Noise Symptom - Whining and Clicking Noises from A-Pillar Area at Low Engine Load/During Overrun: Reworking Torque Support (SY 29/19)

Vehicle type: **Cayenne Turbo (9YA)**

Subject: **Torque support**

*Torque support***Concluding work**

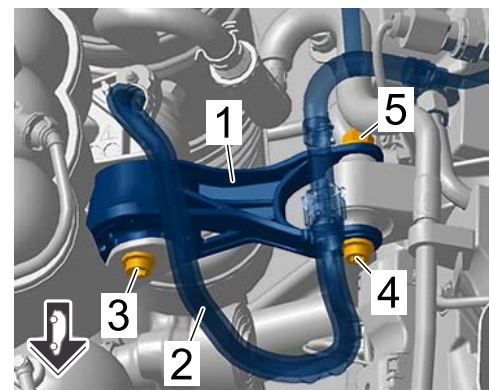
- Work Procedure: 1 Unscrew bolt ⇒ *Torque support -3-* and remove together with washer.
- 2 Install **new** bolt with **new** washer and tighten to **Tightening torque 55 Nm (41 ftlb.)** .
